#### **Technical improvements:**

### **Design improvement**

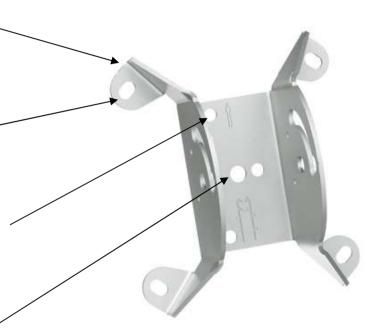
Flat mounting plate (no more need for extra long screws)

Bigger, oval, mounting holes (easier drilling/positioning)

More mounting holes (mounting on eg. joists is possible)

Special mounting hole for standard, low cost, truss clamp

- Inclined ceiling mounting is integrated, no more need for the PFA 9019.
- We have a 2 in 1 solution

Integrated pre-drill pattern for PFA poles. More details on the following sheet

Unique cover included

Both Silver and Black color available

- The PFA poles need <u>one extra</u> <u>mounting hole</u> on <u>ceiling plate side</u>
- Vogel's makes this easy for the installer in 2 ways:
  - 1. All PFA poles (9003-9004-9015-9016) will standard be supplied with two holes on both sides in stead of one. Sept-07
  - 2. For on the job drilling after cutting the poles to a dedicated length, PFA 9010 has an easy integrated pre-drill pattern for exact positioning of the holes
